**ADDENDUM NO. 1**

**July 23, 2026**

The Solanco Area School District | New District Administration Offices & Turf Fields  
CRA Project No. 3706

2 WALL SECTION  
1/2" = 1'-0"

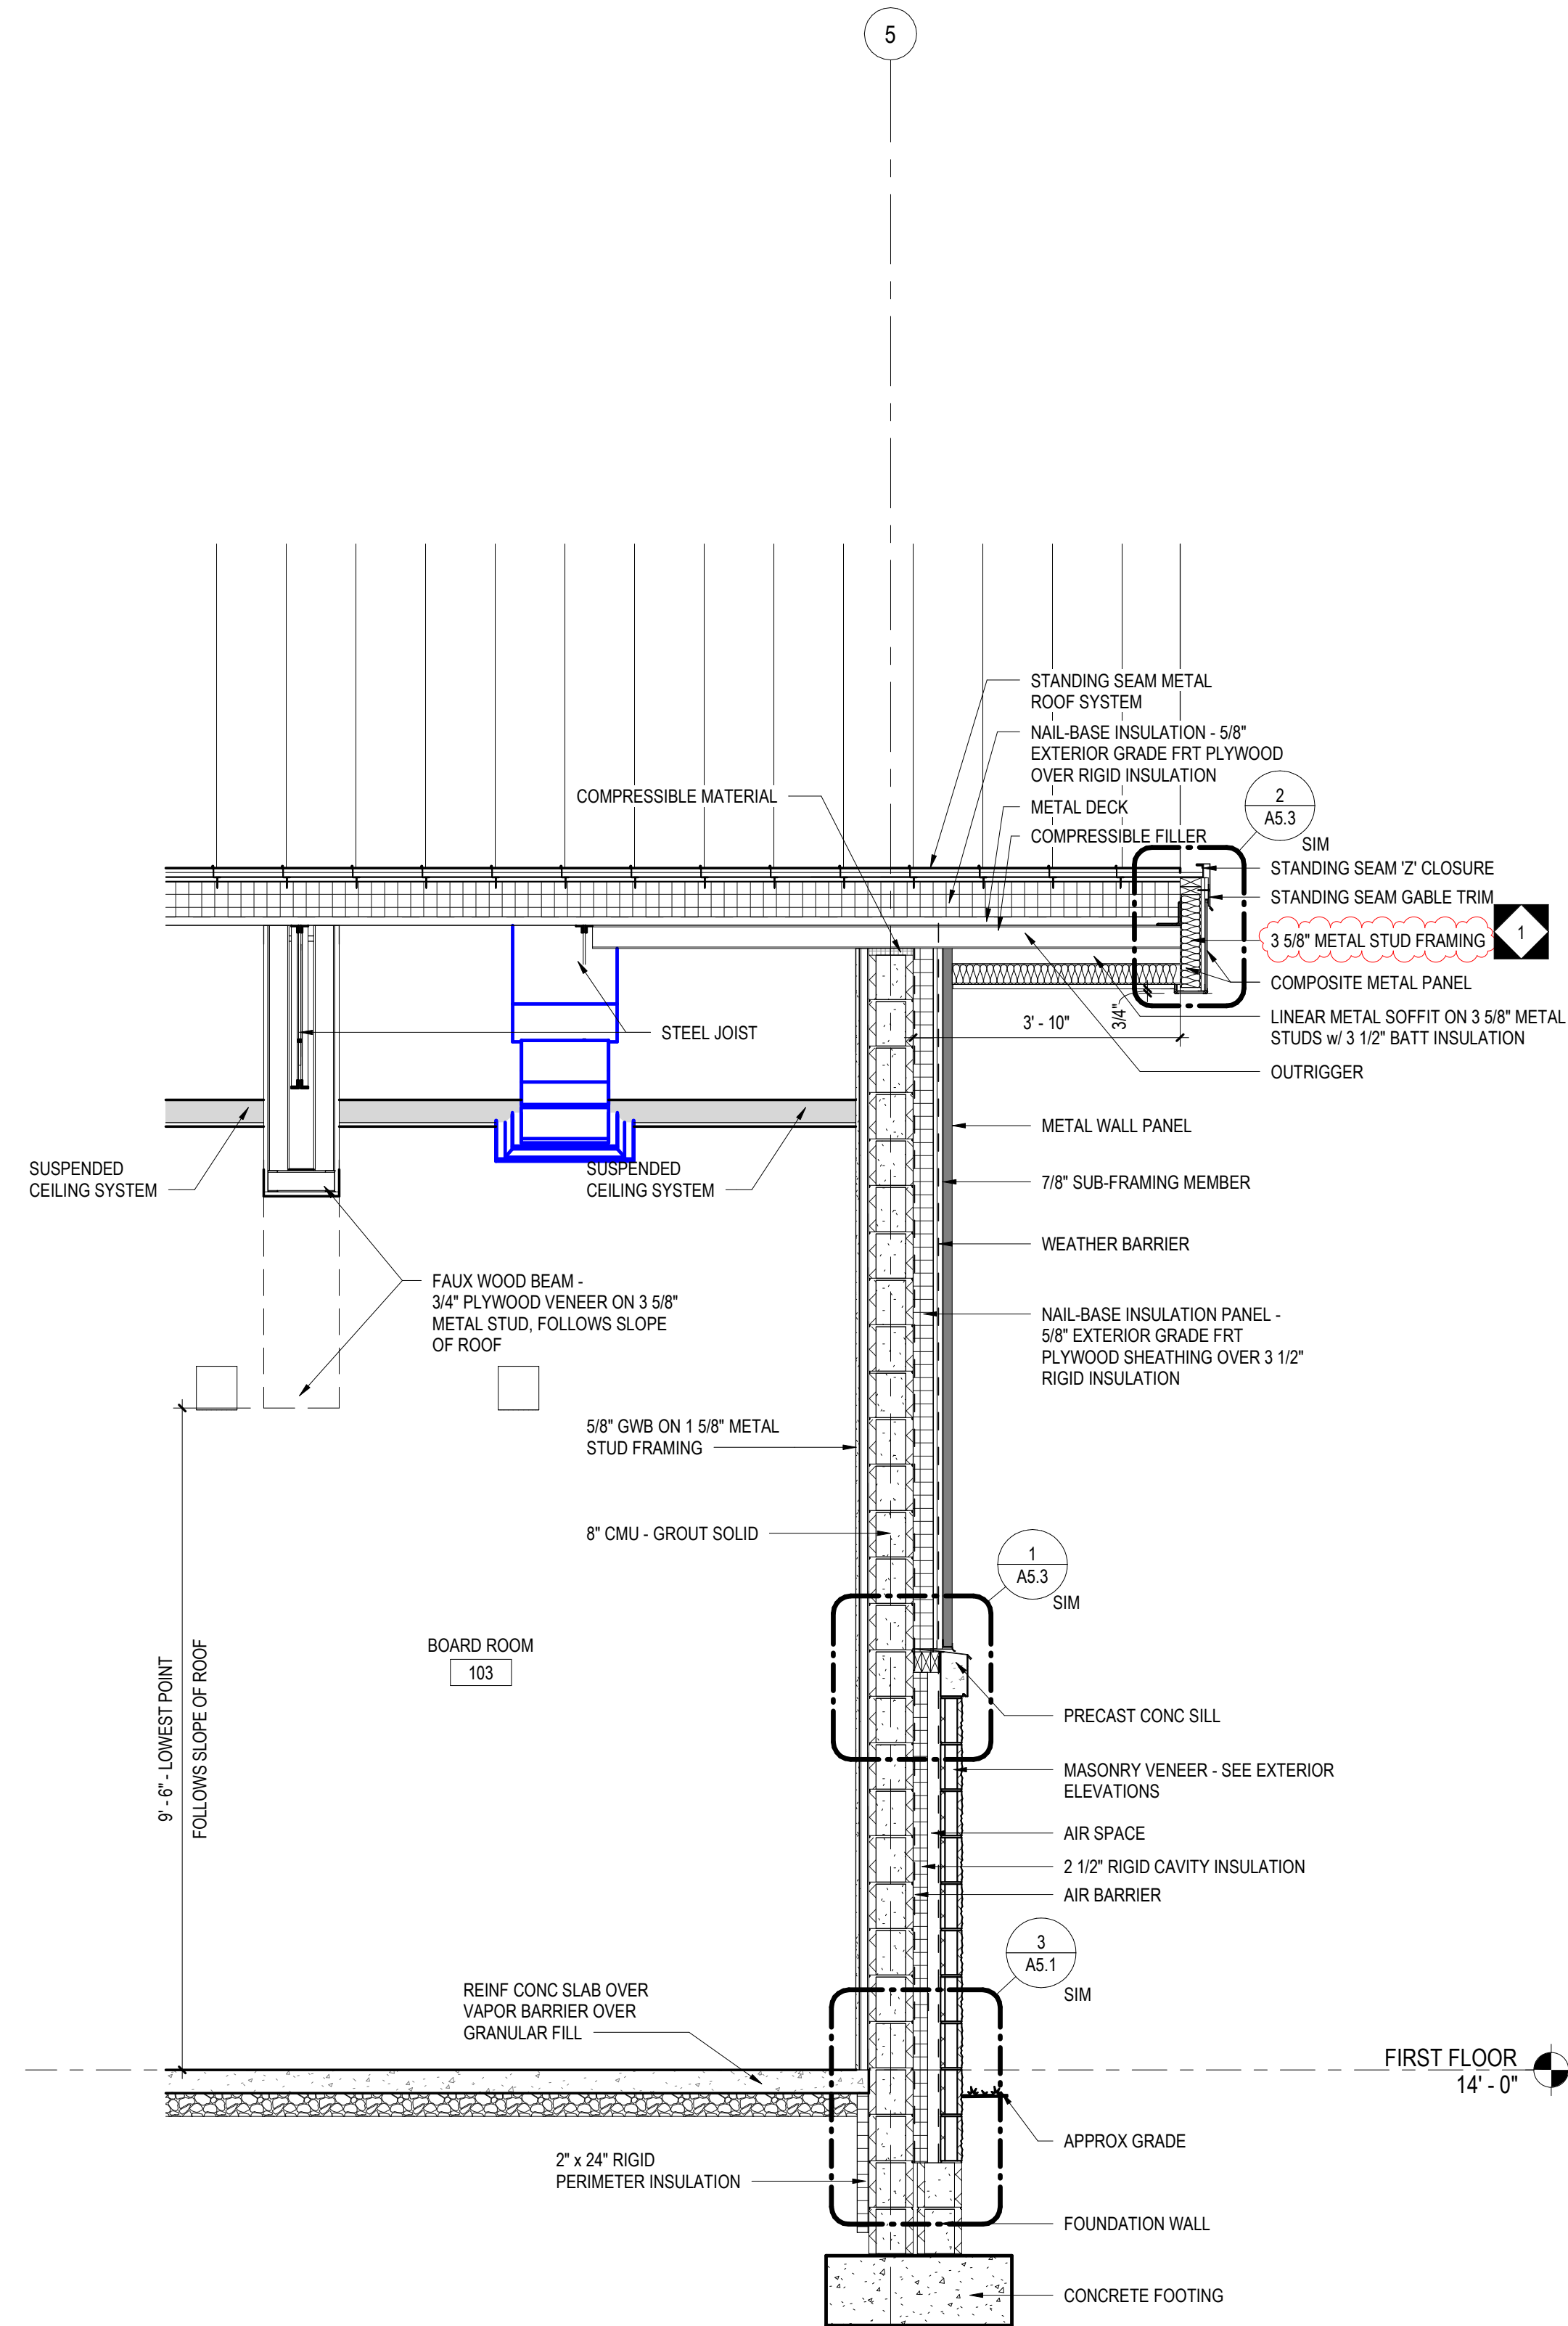
1. **REVISE** section 2/A3.2
2. **REPLACE** sheet in its entirety

1 TYPICAL WALL TO EXPOSED ROOF DECK DETAIL  
A5.2 3" = 1'-0"

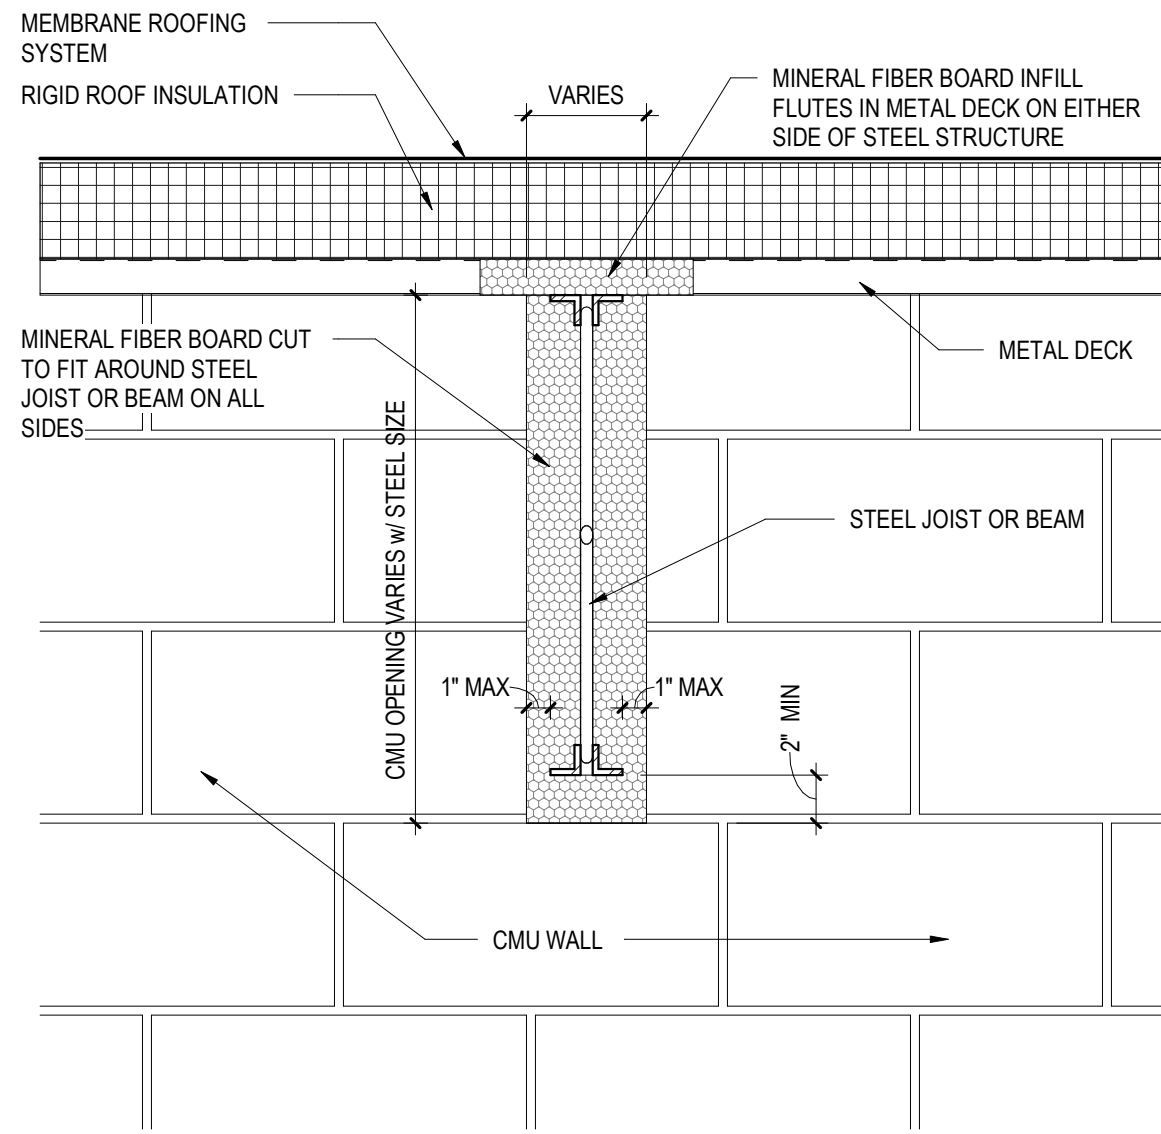
1. **REVISE** detail 4/A5.2
2. **REPLACE** sheet in its entirety

1 METAL WALL TO PRECAST  
A5.3 3" = 1'-0"

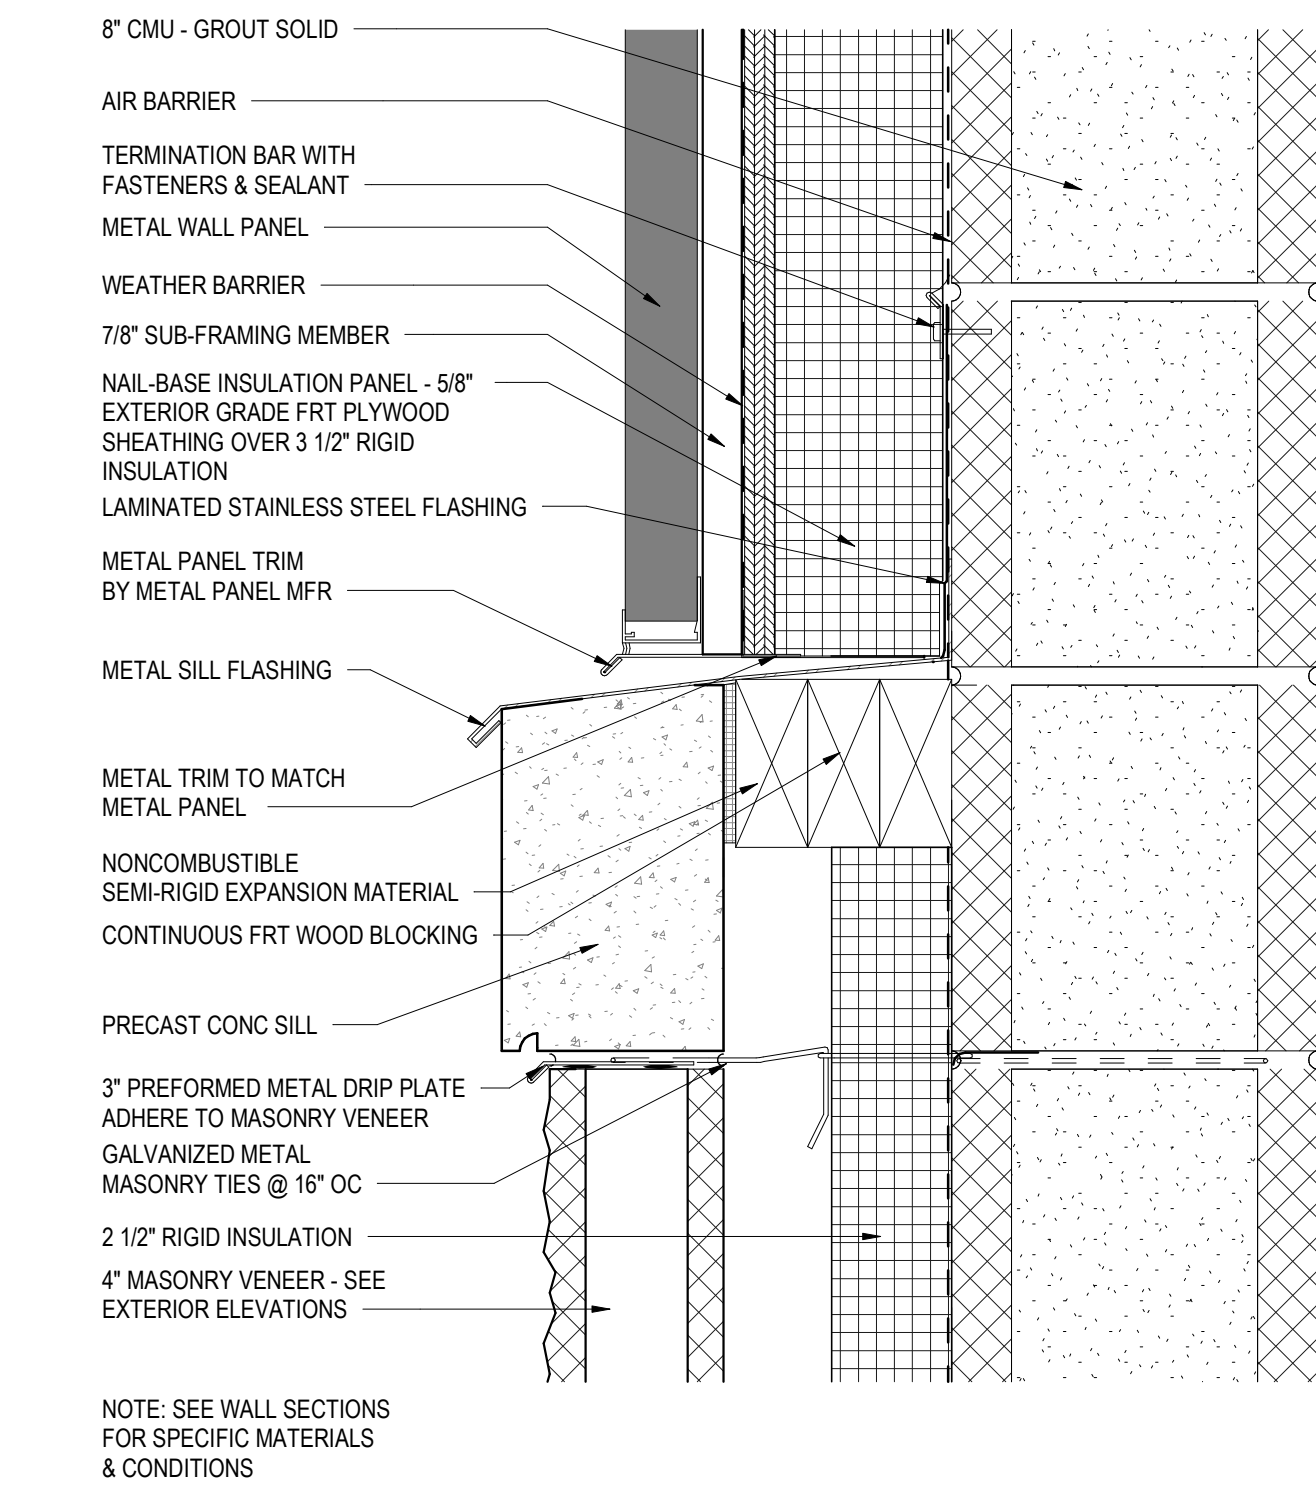
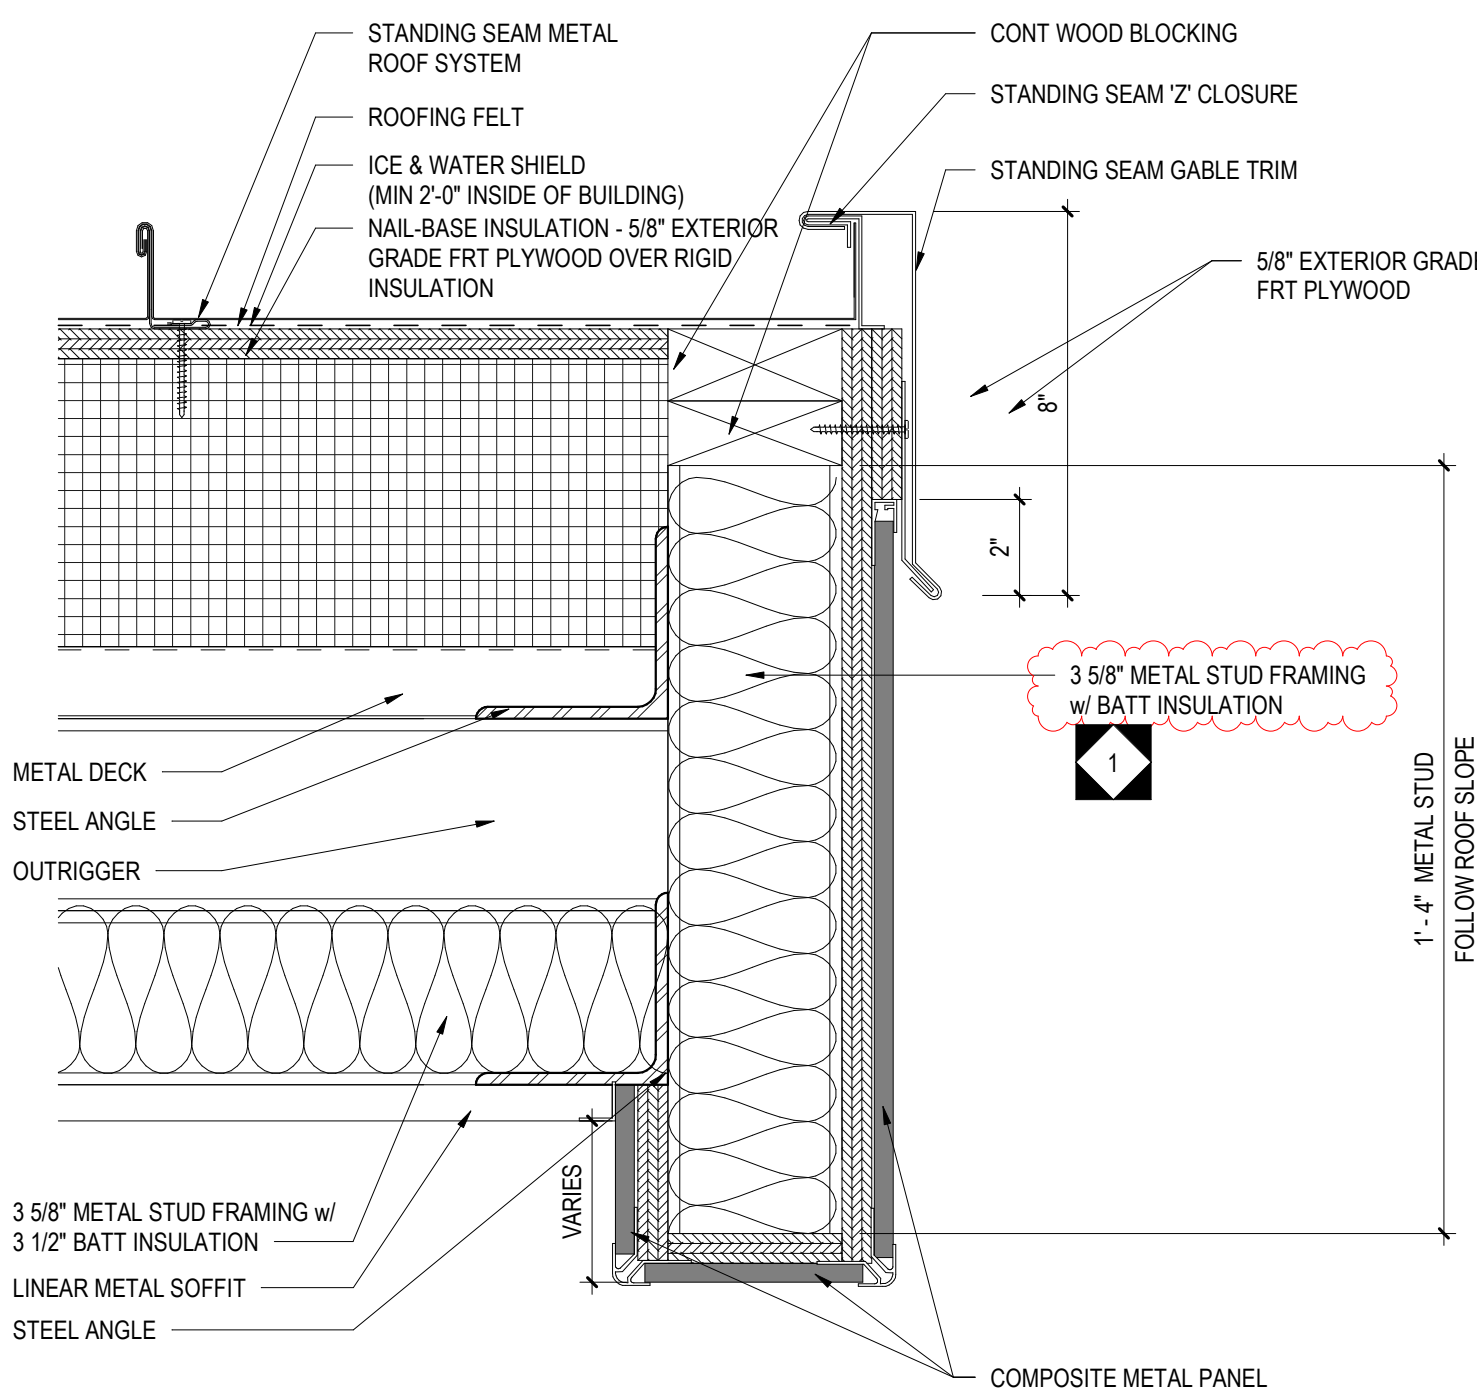
1. **REVISE** details 1-2/A5.3
2. **REVISE** detail 8/A5.3
3. **REPLACE** sheet in its entirety
